**AMENDMENTS TO THE DRAWINGS**

This amendment is in response to the Official Action dated March 16, 2006. Claims 2-5 have been canceled, claim 1 has been amended, and claims 6-18 have been added; as such claims 1 and 6-18 are now pending in this application. Claims 1, 6 and 18 are independent claims. Reconsideration and allowance is requested in view of the claim amendments and the following remarks.

Application No. 10/521,147  
Amendment dated June 18, 2007  
Reply to Office Action of March 16, 2007

FIG. 6

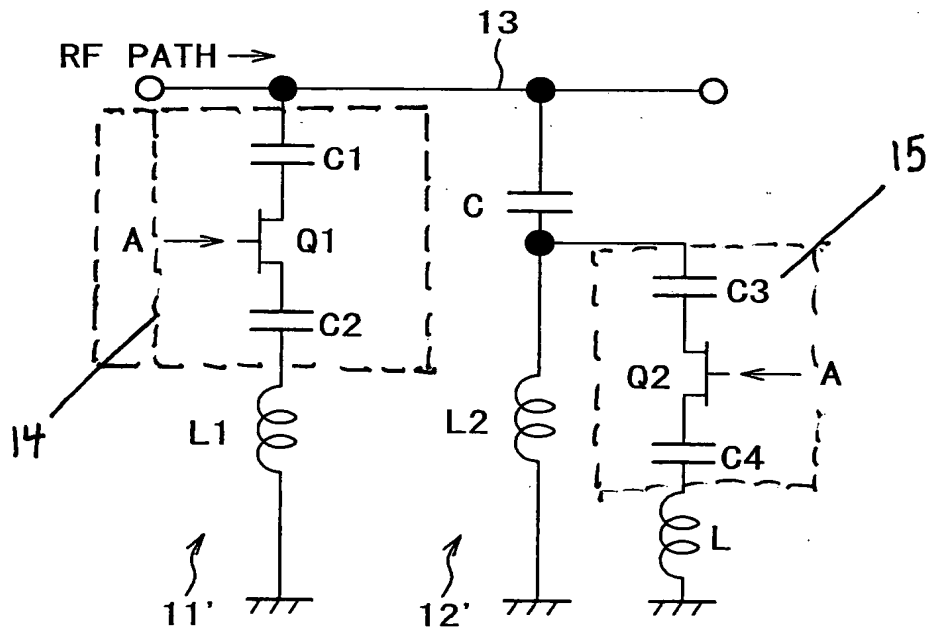
The attached sheet(s) of drawings includes changes to FIG. 6, FIG. 8, FIG. 9, FIG. 10, FIG. 12 and FIG. 13.
